25/00486,

/OUT – Hallam Land, Knowsley Village – ESS Consultation Comme

KMBC Original Comments "

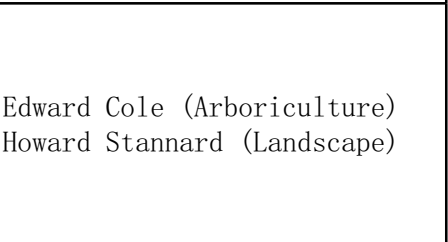
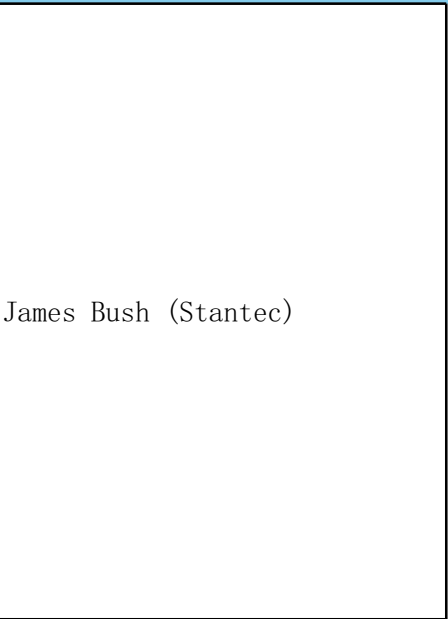
There are too many rear and side facing properties against the POS, especially in relation to the ancient woodland on the north and southern sides, the layout as it is will only cause problems on the estate moving forward with the lack of natural surveillance.

It is noted that the supporting plans (other than the Parameters Plan) are all illustrative at this outline stage so are not to be approved/ commented on in detail. Notwithstanding this, the testing layout that has informed the plans (**Extract of plan included to side/ below** - which is again illustrative and does not form part of the application submission), includes 96% front/side facing properties which would naturally be corner turners (side elevation is the primary elevation (a front) with very limited rear (3 units of 700) with the ecology corridor updated in the south-east corner. Pink on the plan illustrates frontages (this includes corner turner units as their primary elevation is the side, so a front). Blue illustrates rears which are nominal. Accordingly the proposals do seek to maximise outward facing development ensuring good levels of natural surveillance.
